HISTORIC AND DESIGN REVIEW COMMISSION

July 1, 2020

HDRC CASE NO: 2020-251
ADDRESS: 2158 W KINGS HWY
LEGAL DESCRIPTION: NCB 6825 BLK LOT 15 & W 12.5 FT OF 14
ZONING: R-6, H
CITY COUNCIL DIST.: 7
DISTRICT: Monticello Park Historic District
APPLICANT: John Speegle, speegle & KIM-davis Architecture
OWNER: William Hazlewood
TYPE OF WORK: Enclosure of front porch with windows and door
APPLICATION RECEIVED: April 03, 2020
60-DAY REVIEW: Not applicable due to City Council Emergency Orders
CASE MANAGER: Huy Pham

The applicant is requesting a Certificate of Appropriateness for approval to enclose the front porch to feature aluminum windows in the two front arches and doors in the side-facing arches.

RIGHT SIDE
ELEVATION
(LEFT SIDE SIM.)

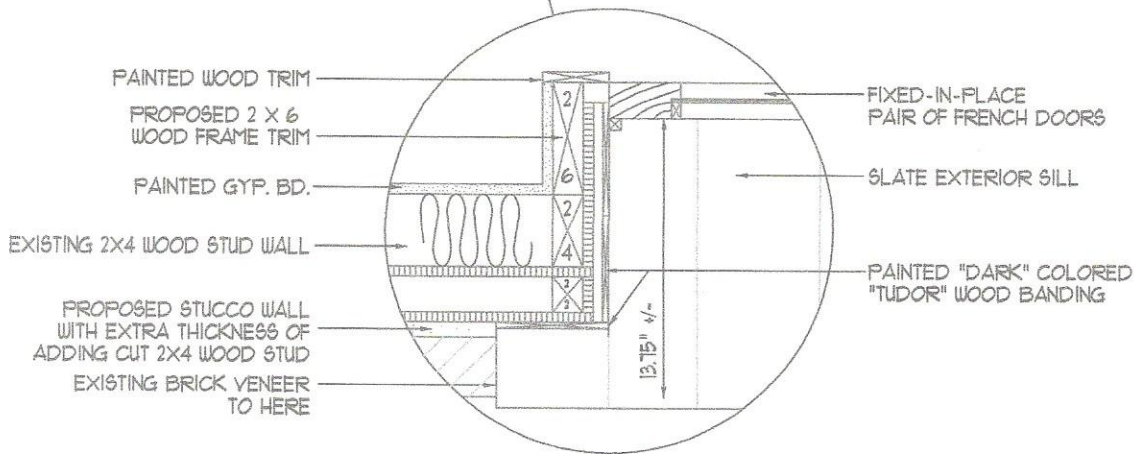
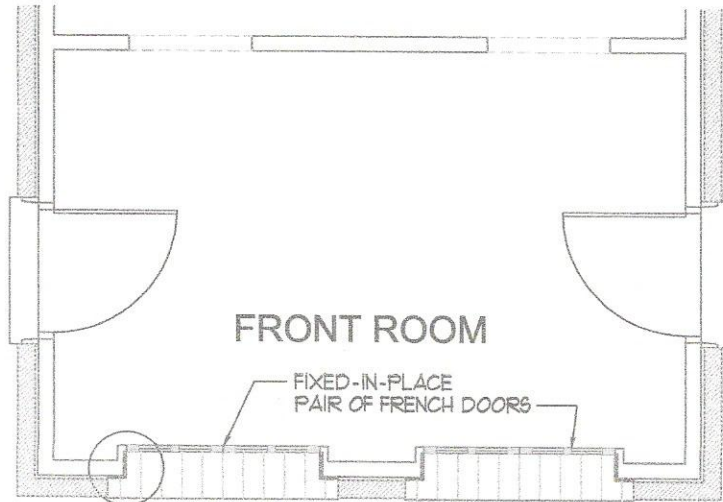
- d. PORCH ENCLOSURE – The applicant has proposed to demolish the arched porch and reconstruct as an enclosed room with a salvaged brick masonry base recessed steel windows, and stucco siding with Tudor-influenced trim. Per the Guidelines for Exterior Maintenance and Alterations 2.B.i., applicants should refrain from enclosing front porches. Staff finds that the proposed enclosure is inconsistent with the Guidelines and departs from a major character-defining feature of the Tudor Revival structure. Staff also remains concerned about the quality of the submitted drawings and the inconsistency between the drawings and the initiated work without approval, including door and window details.

Staff does not recommend approval based on finding c. The applicant should perform in-kind reconstruction as approved.

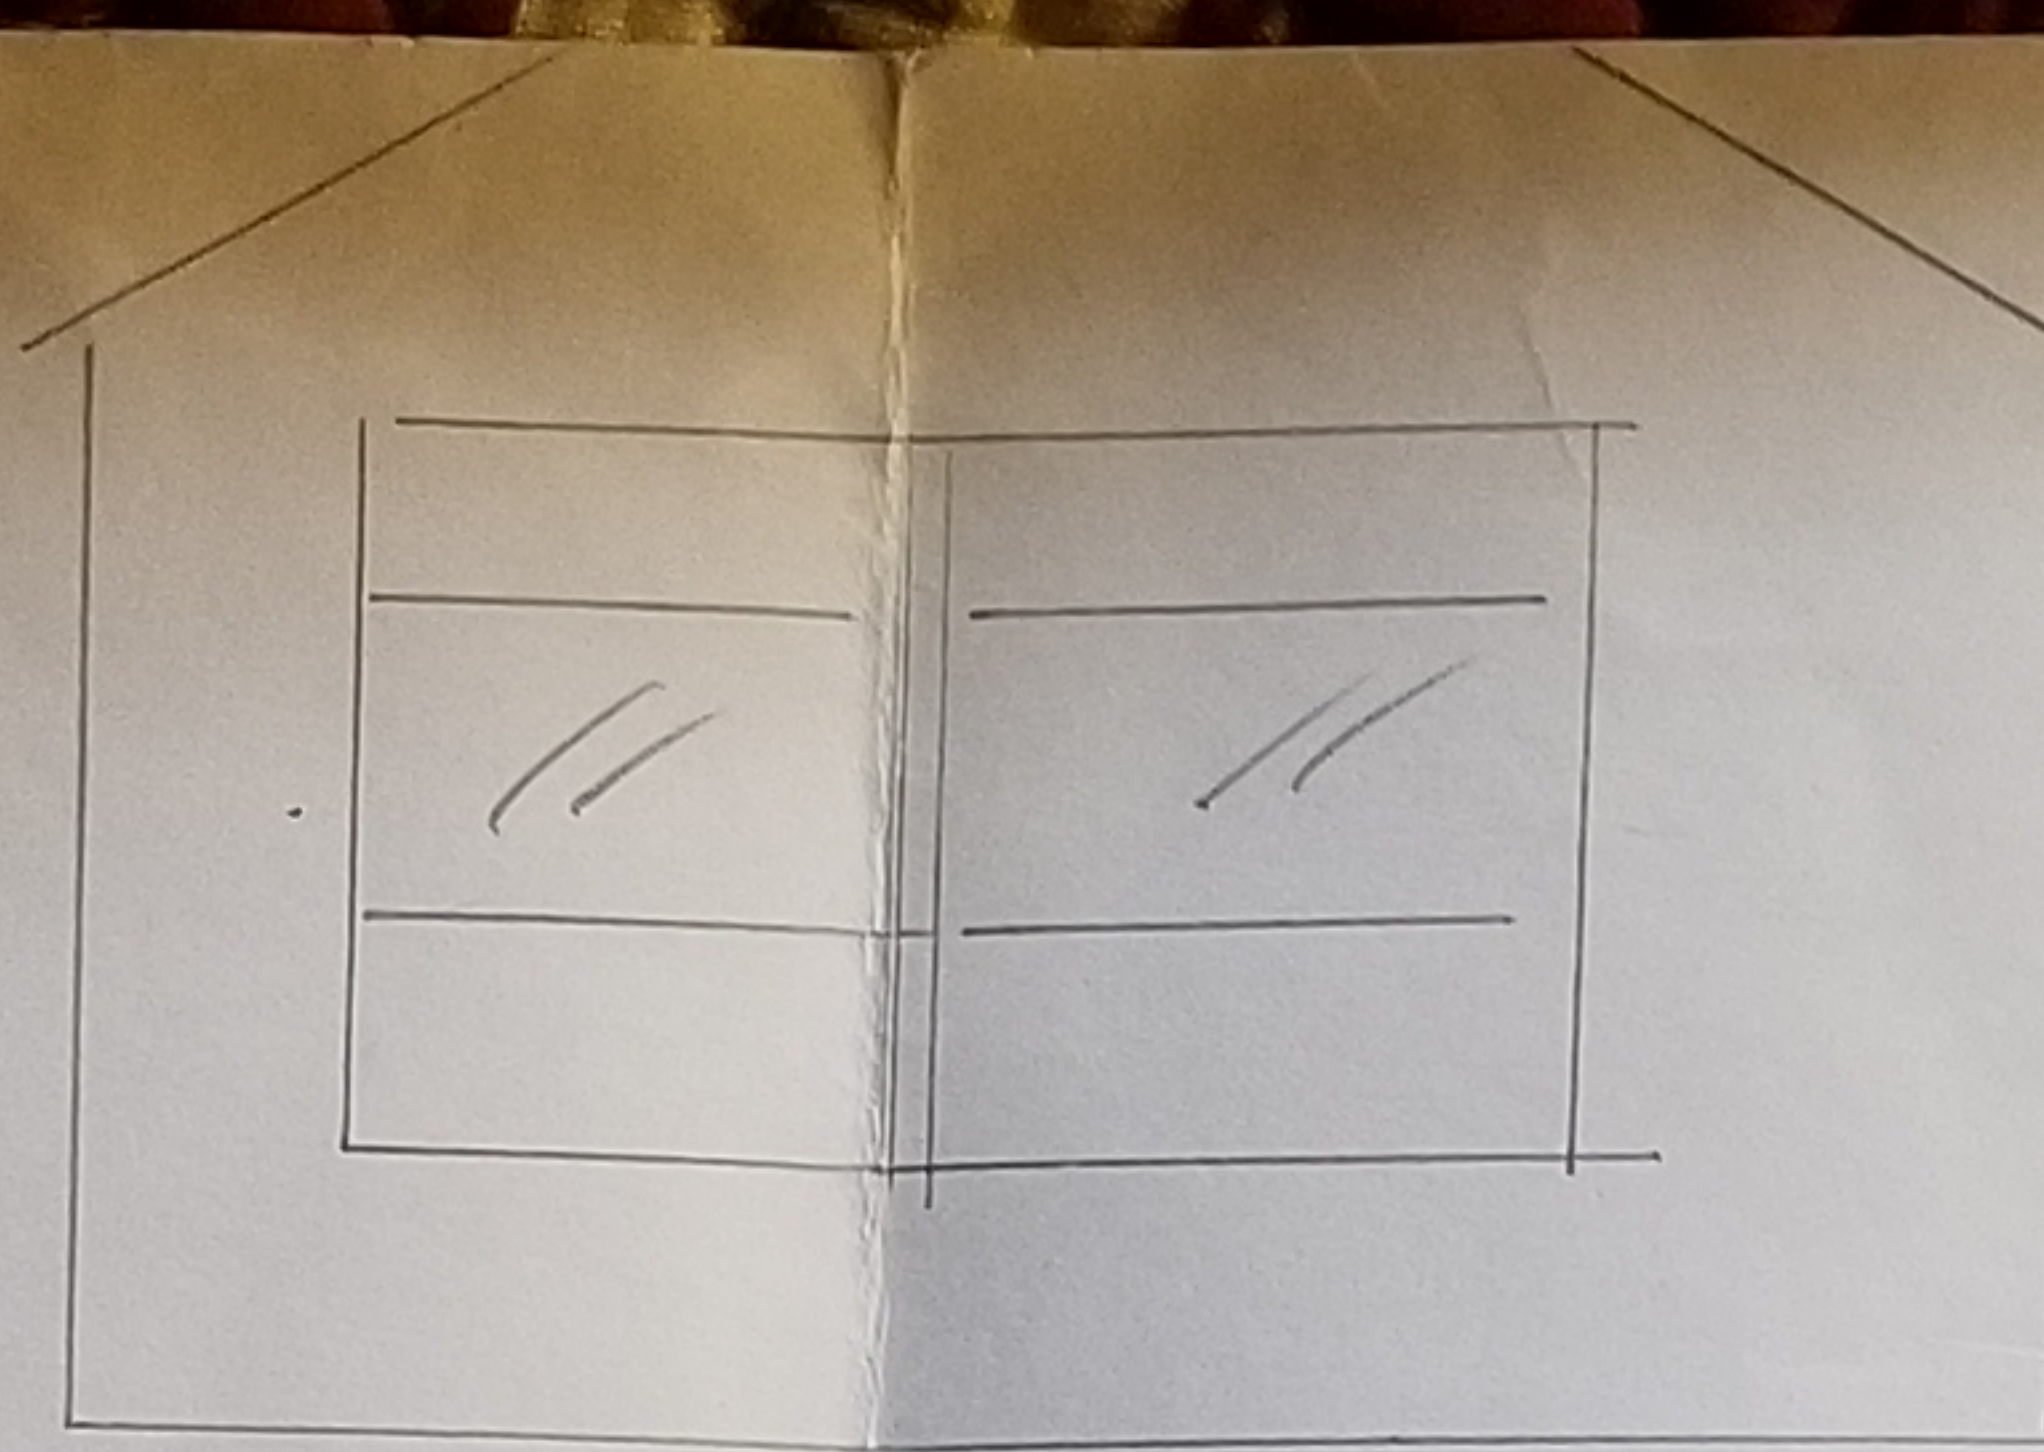
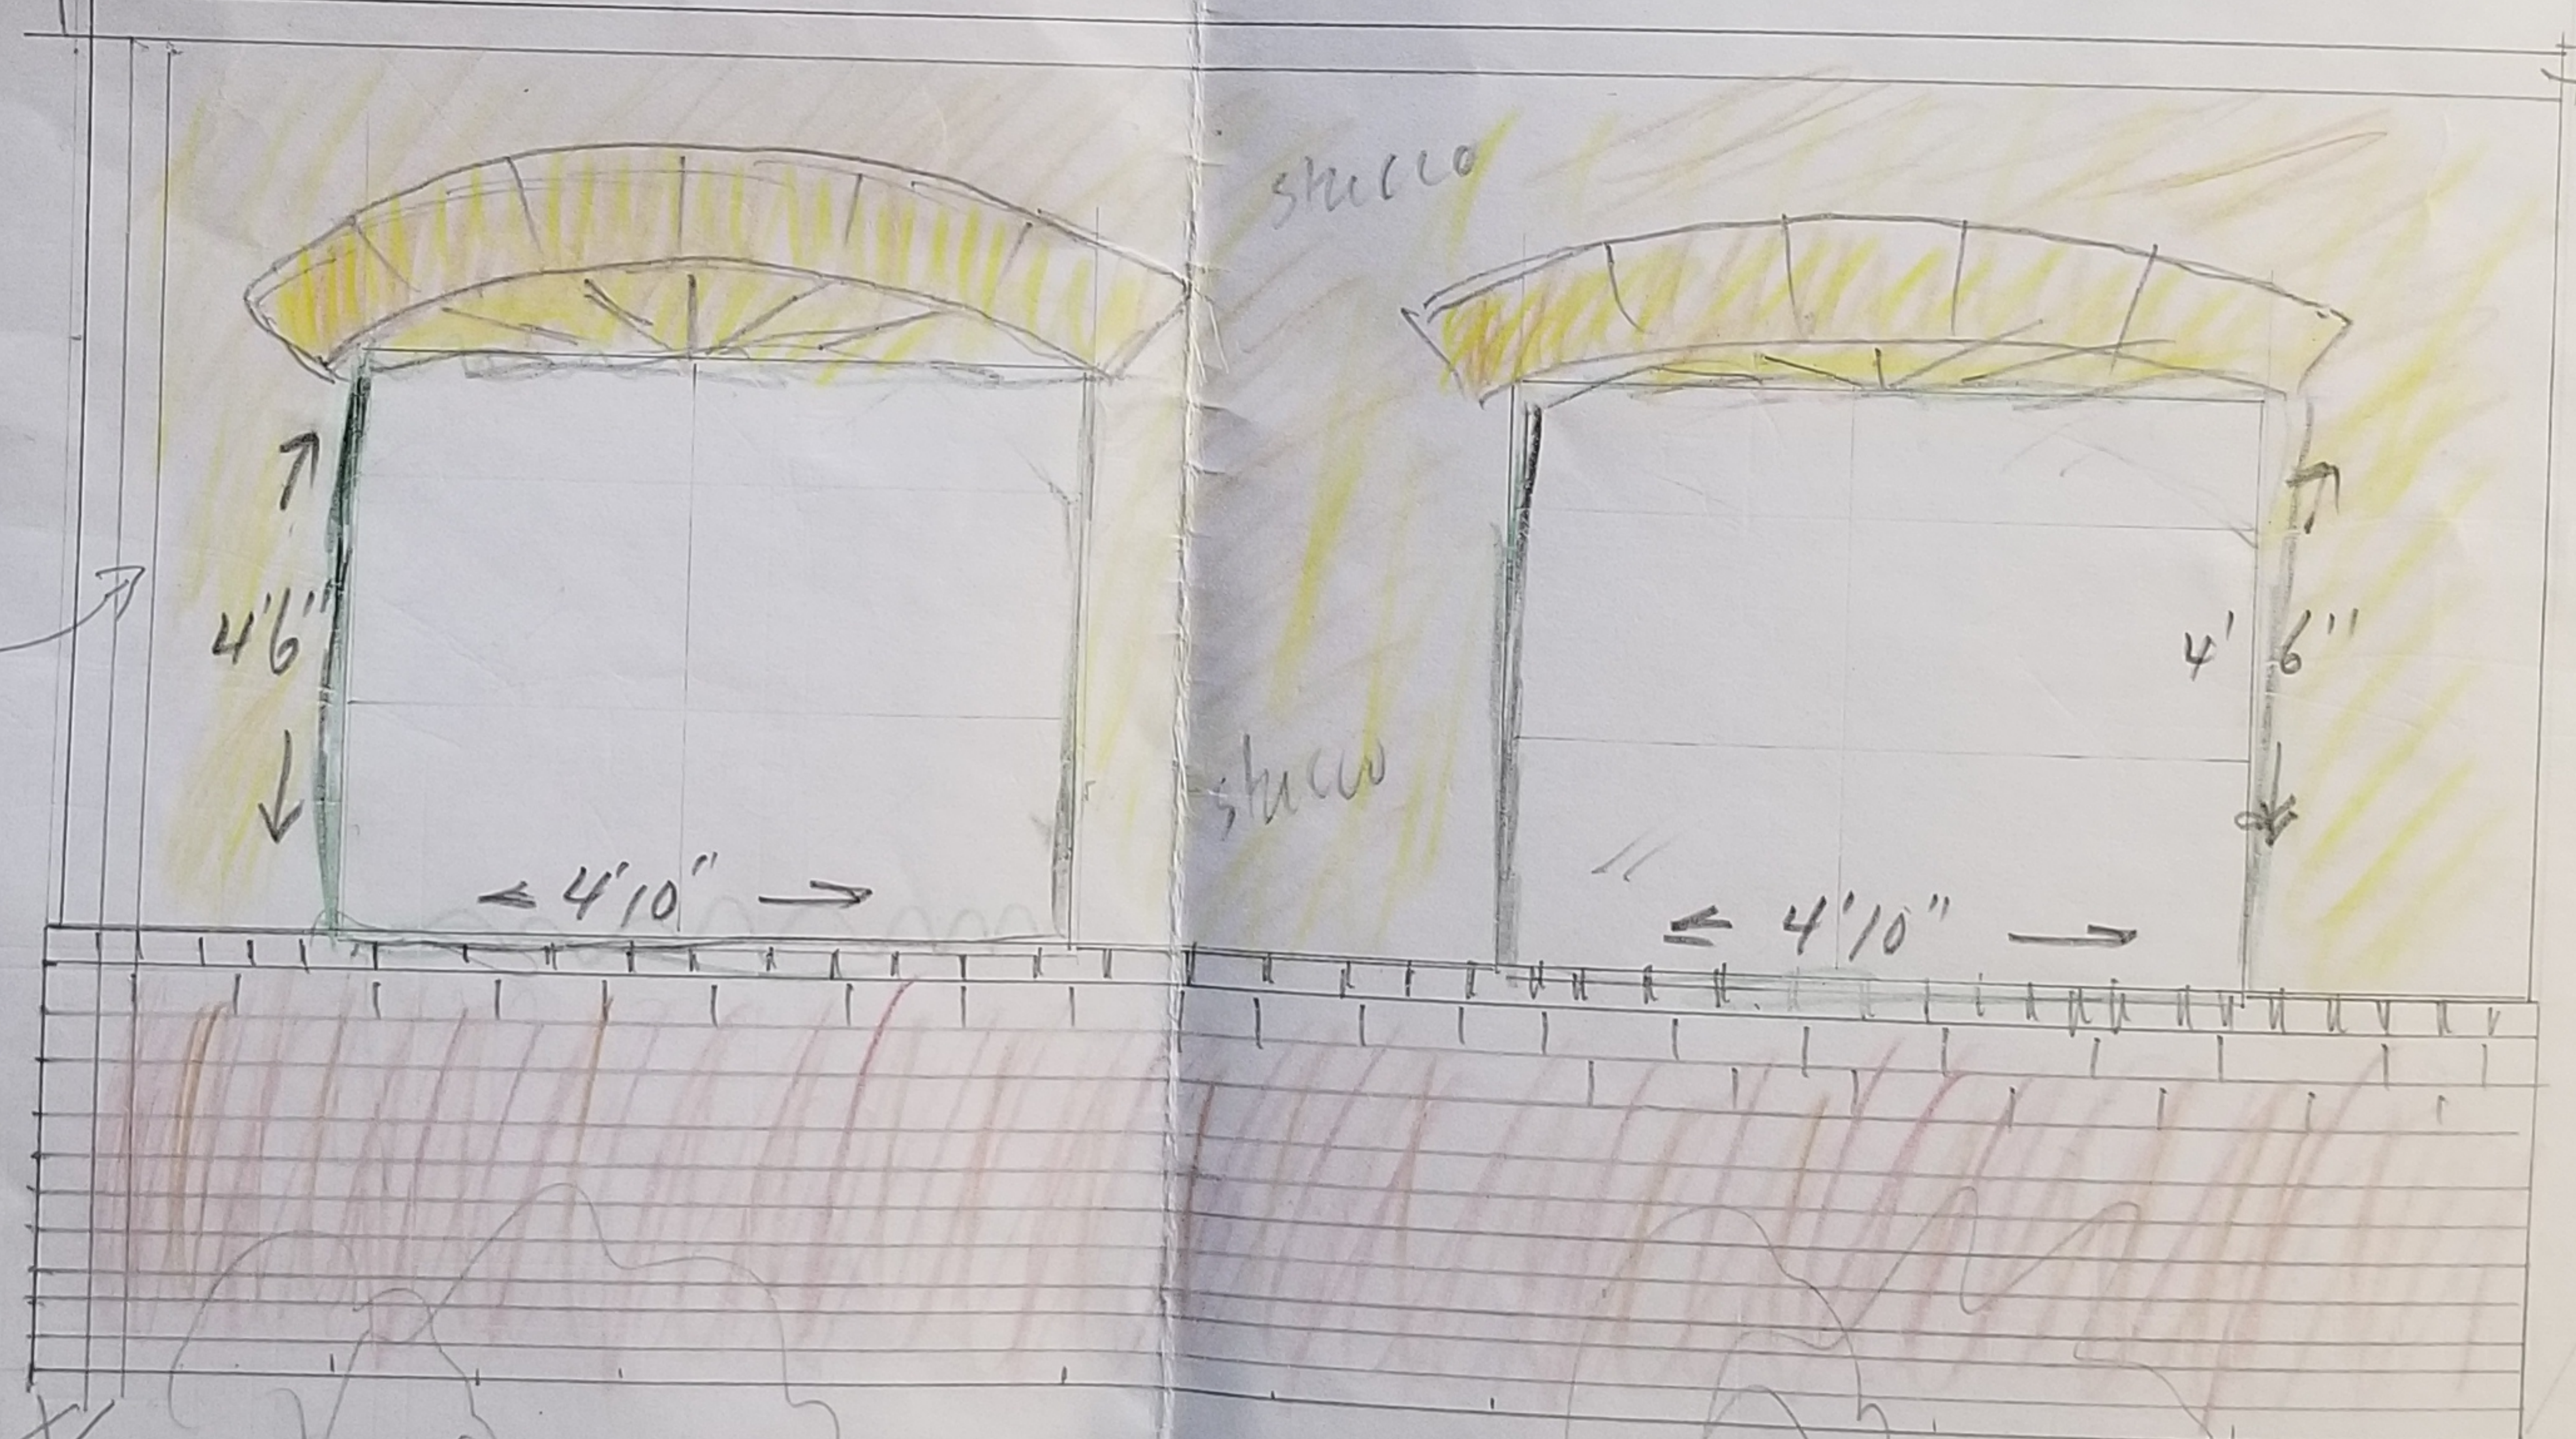
- Measured, dimensioned drawings that illustrate how a screened porch will look as installed on your home. The drawings you submitted are a good start though they should have measurements and dimensions.
